SUMMERGLEN SUBDIVISION, REVISED

SUBDIVISION OF LOTS LOTS 4, 5 & 8-10

APPLICATION NUMBER 5 DATE June 1, 2017
APPLICANT Summerglen Subdivision, Revised Subdivision of Lots 4, 5 & 8-10
REQUEST Subdivision

DETAIL SITE PLAN

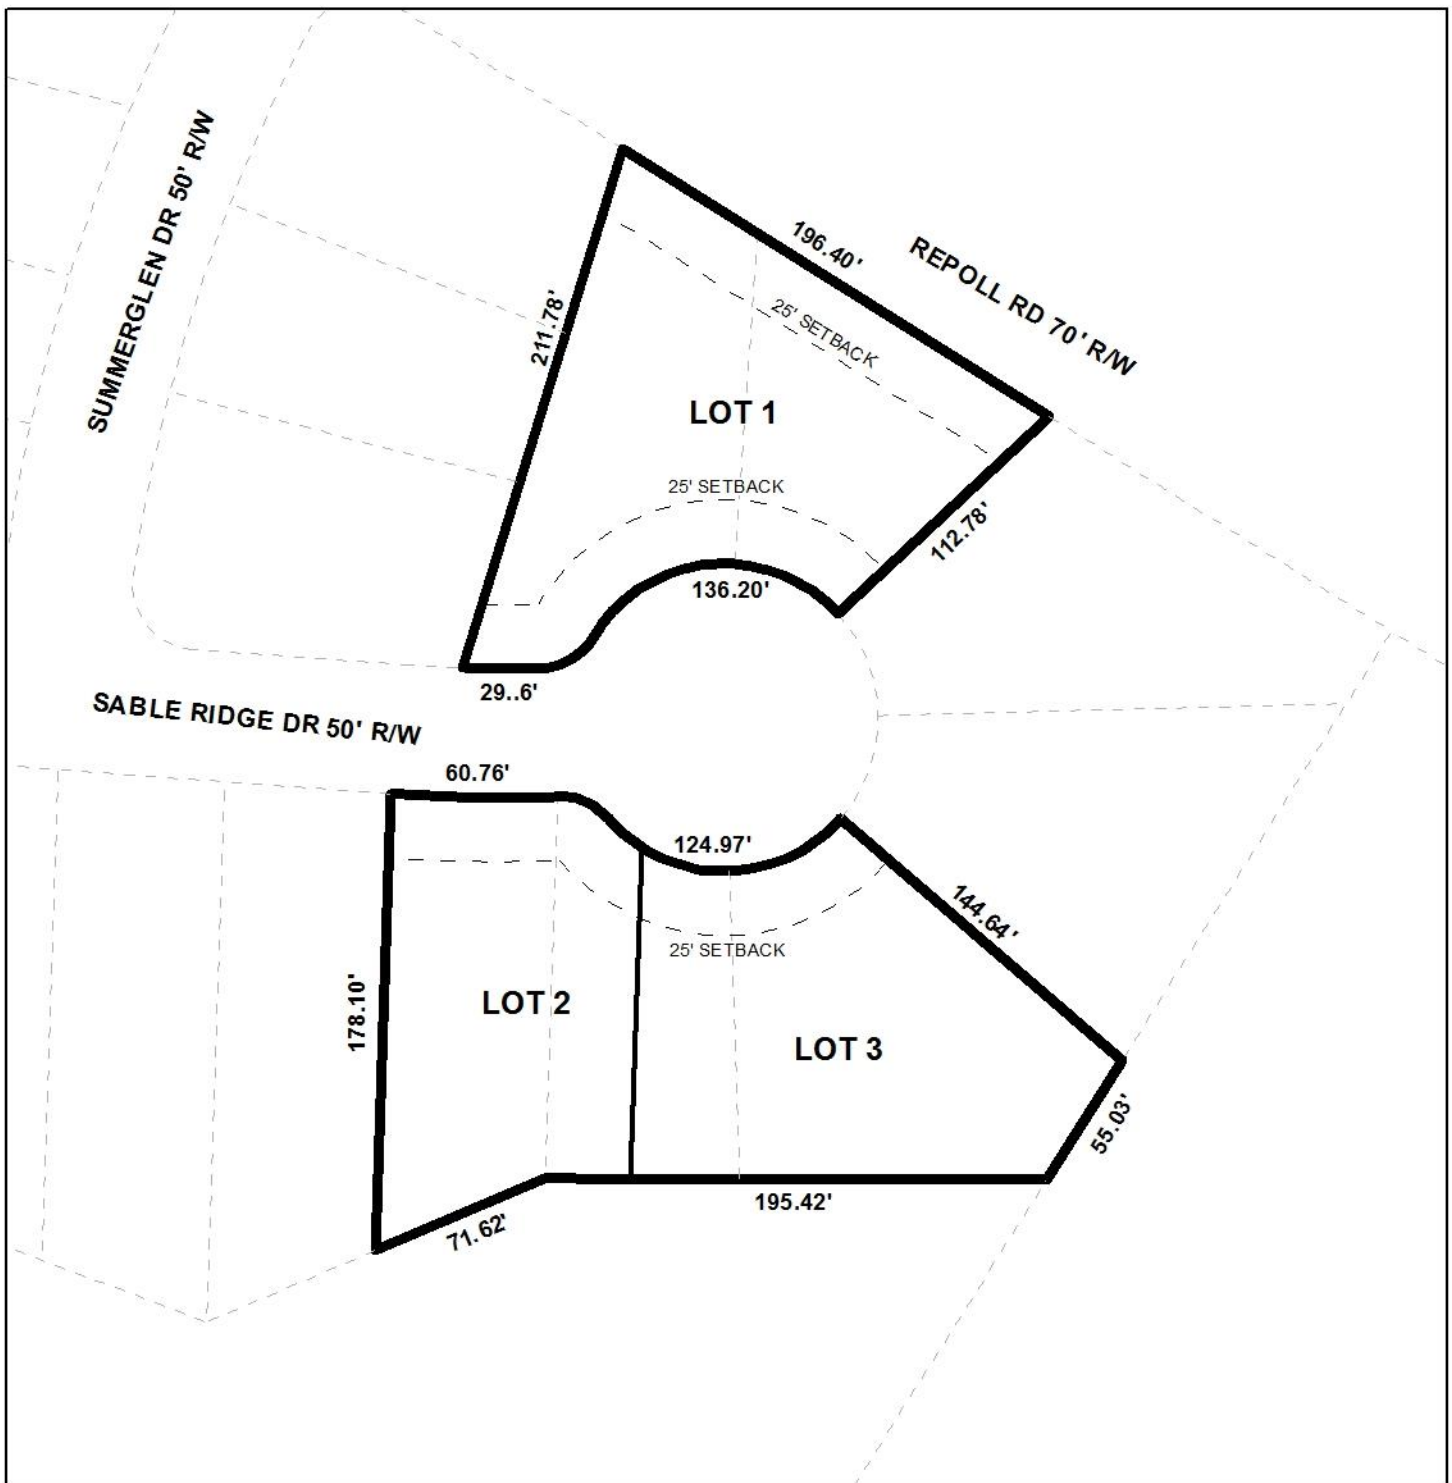
The proposed lots front Sable Ridge Drive, a minor street that requires a 50' right-of-way width. It should be noted that Sable Ridge Drive is a closed-end street requiring a turnaround diameter of 120'. The preliminary plat provides a 50' right-of-way width for Sable Ridge Drive as well as adequate turnaround space. If approved, the right-of-way width should be retained on the Final Plat. The rear of proposed Lot 1 faces Repoll Road, a minor street, without curb and gutter, that requires a 60' right-of-way width. The preliminary plat illustrates a 70' right-of-way width to Repoll Road and, if approved, should be retained on the Final Plat.

A 25' foot minimum building setback line is illustrated on the preliminary plat along Sable Ridge Drive for the proposed Lots 2 and 3. A 25' foot minimum building setback line is illustrated along both Sable Ridge Drive and Repoll Road for the proposed Lot 1. If approved, the minimum building setback lines for proposed Lots 1, 2 and 3 should be retained on the Final Plat.

As a means of access management, a note should be placed on the Final Plat, if approved, stating that Lot 1, 2, and Lot 3 are limited to one curb cut each to Sable Ridge Drive , with changes in

the size, design and location of the curb-cuts to be approved by Mobile County Engineering and conform to AASHTO standards.

- 1) Retention of 50' right-of-way-width to Sable Ridge Drive;
- 2) Retention of 70' right-of-way width along Repoll Road;
- 3) Retention of the lot size information in both square and in acres on the Final Plat;

- 4) Retention of 25' minimum building setback line along the Sable Ridge Drive and Repoll Road;
- 5) Placement of a note on the Final Plat stating that Lot 1, 2 and 3 are limited to one curb cut each to Sable Ridge Drive, with changes in the size, design and location of the curb-cuts to be approved by Mobile County Engineering and conform to AASHTO standards;
